TO: District of Columbia Zoning Commission
FROM: Jennifer Steingasser, Deputy Director, Development Review & Historic Preservation
DATE: May 2, 2016
SUBJECT: Hearing Report – ZC 15-15 – Consolidated PUD at 1500 Harry Thomas Way / 1611-1625 Eckington Place, N.E., with Related Map Amendment from M to CR; Square 3576, Lots 2001-2008

I. OFFICE OF PLANNING RECOMMENDATION AND SUMMARY OF APPLICATION STATUS

Figure 4. Applicant's Preferred Circulation and Parking/Loading Entrance Alternative

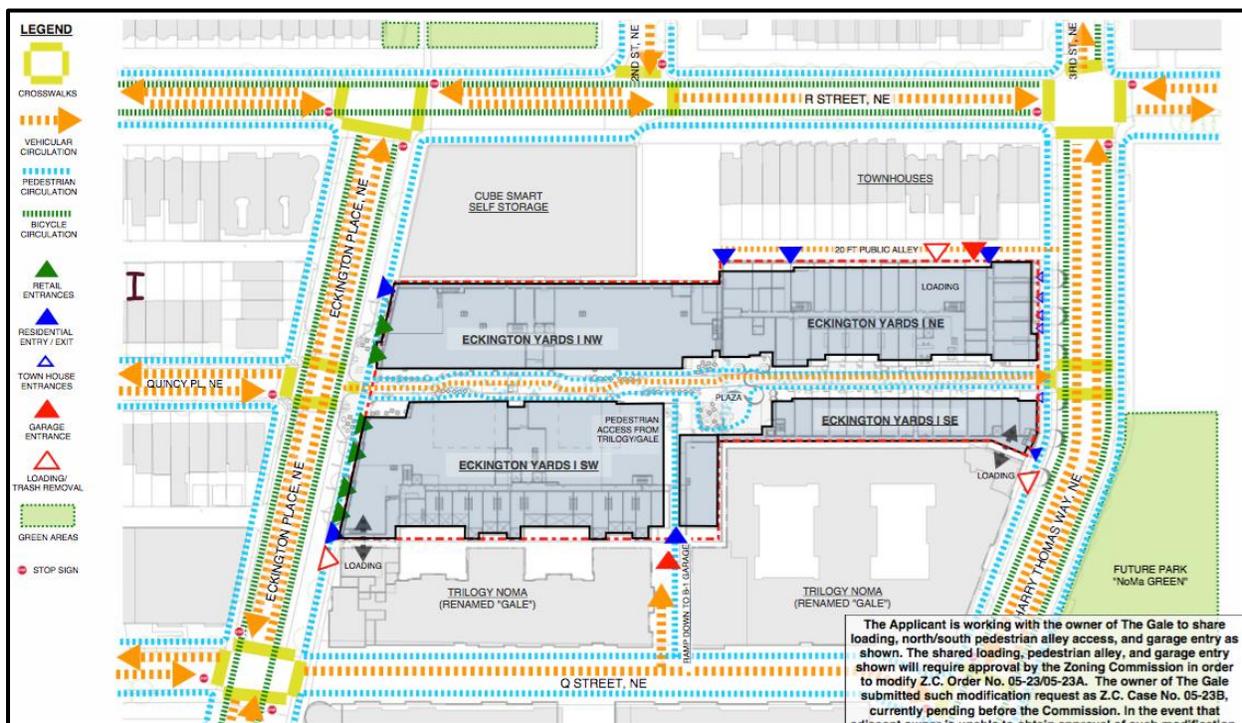
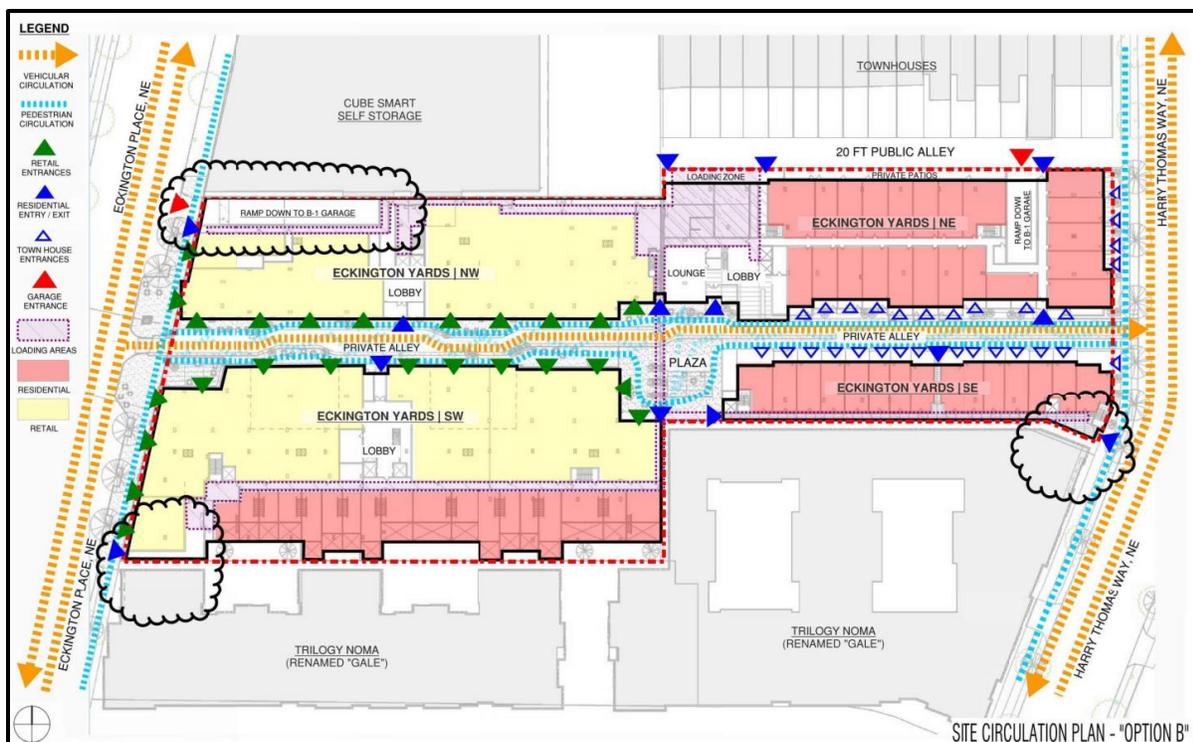
The request to provide an entry to the project's parking garage from Q Street, via a connection to the existing garage constructed for PUD 05-23 is dependent on Commission approval of a modification requested for that PUD.

- OP would support the granting of flexibility for the proposed connection, provided additional information is provided illustrating the proposed connection and the impact, if any, on existing parking or loading in that garage

The applicant's April 22, 2016 filing notes that, if the Commission approves The Gale apartment's application for a modification to ZC Order 05-23, the applicant's preferred vehicular circulation alternative would be that shown on Sheet A1.07 of Case Exhibit 23, rather than the one shown previously on Sheet A1.0BB of February's submittal. The alternative plans are illustrated below.

The preferred alternative would eliminate a proposed garage entrance at the northwest corner of the site and modify an existing entrance to the Gale garage on the north side of Q Street to permit vehicles to enter the proposed PUD 15-15’s garage via a pass-through from the Gale’s Q Street garage entrance. This alternative would also result in the addition of a pedestrian passage from Q Street, through the Gale development, to the Plaza proposed for the Eckington Yards PUD.

If the modification to the PUD 05-23 Order is not approved, the vehicular circulation and loading for Application 15-15 would revert to the alternative that does not include a Q Street entrance.
